Project	IEEE 802.16 Broadband Wireless Access Working Group < <a href="http://ieee802.org/16">http://ieee802.org/16</a> >	
Title	In-band Semi-transparent Relay Frame Structure	
Date Submitted	2007-04-24	
Source(s)	Kanchei (Ken) Loa, Yi-Hsueh Tsai, Yung-Ting Lee, Heng-Iang Hsu Shiann-Tsong Sheu, Frank C.D. Tsai, Youn-Tai Lee, Chih-Chiang Hsieh, Hua-Chiang Yin, Institute for Information Industry 8F., No. 218, Sec. 2, Dunhua S. Rd., Taipei City, Taiwan. [add co-authors here]	Voice: +886-2-2739-9616 <a href="mailto:loa@iii.org.tw">loa@iii.org.tw</a>
Re:	IEEE 802.16j-07/013: "Call for Technical Comments Regarding IEEE Project 802.16j"	
Abstract	This contribution proposes in-band semi-transparent relay frame structure	
Purpose	Text proposal for 802.16j Baseline Document	
Notice	This document has been prepared to assist IEEE 802.16. It is offered as a basis for discussion and is not binding on the contributing individual(s) or organization(s). The material in this document is subject to change in form and content after further study. The contributor(s) reserve(s) the right to add, amend or withdraw material contained herein.

# In-band Semi-transparent Relay Frame Structure

Figure 1 Example of configuration for an in-band semi-transparent relay frame structure

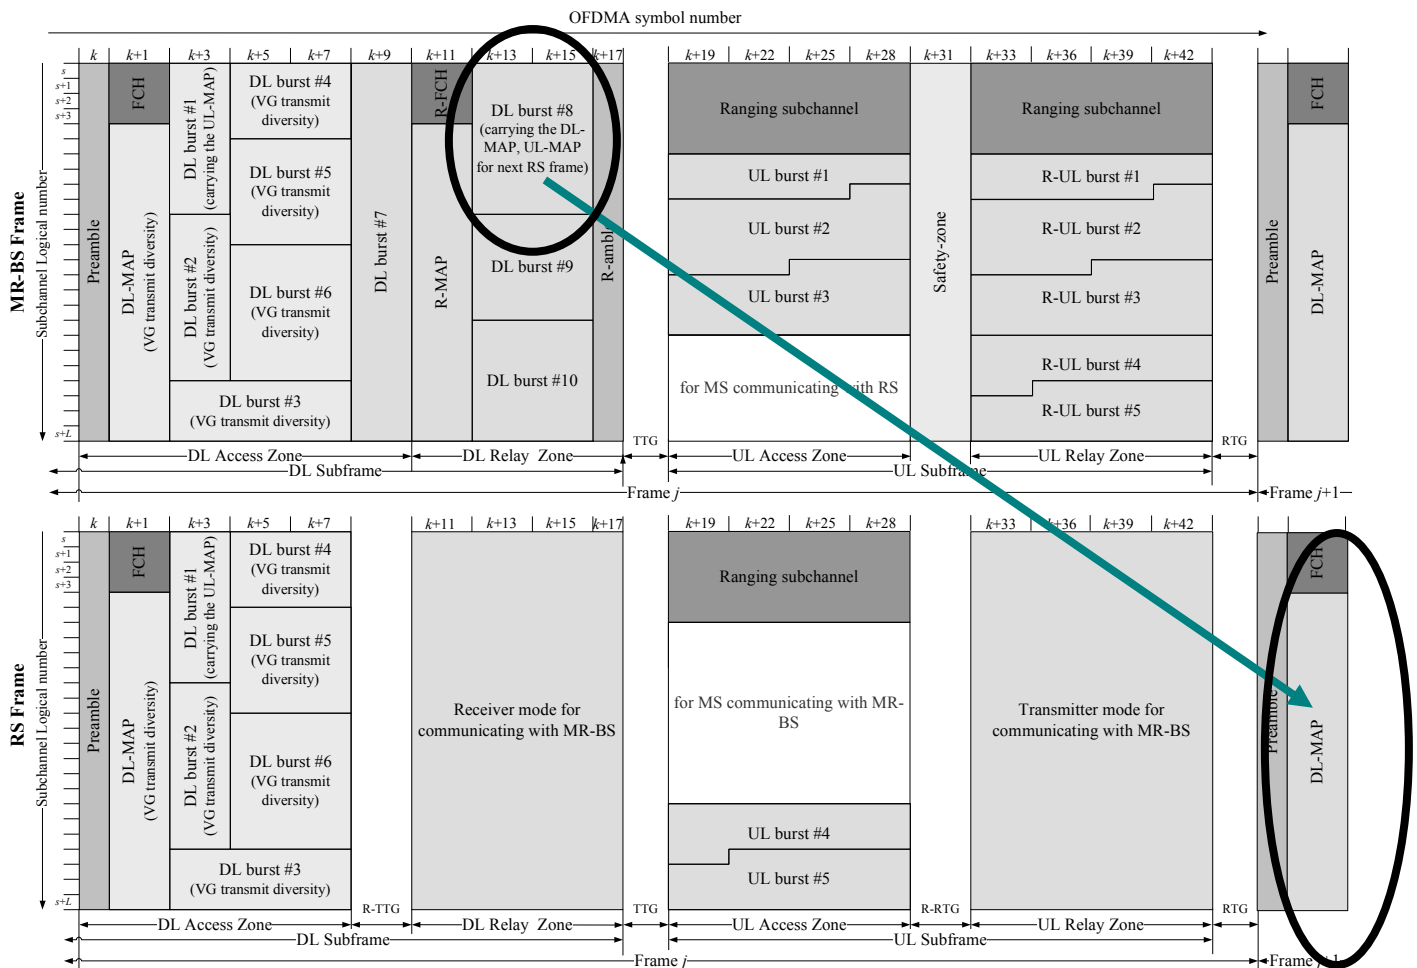
This contribution proposes an in-band semi-transparent RS to amend the section 8.4.4.7 in IEEE 80216j-06/026r3.

A semi-transparent RS shall utilize non-transparent frame structure. The semi-transparent RS shall transmit corresponding DL frame-start preamble, FCH, DL-MAP/UL-MAP, and DCD/UCD of the assigned virtual group at the beginning of the frame.
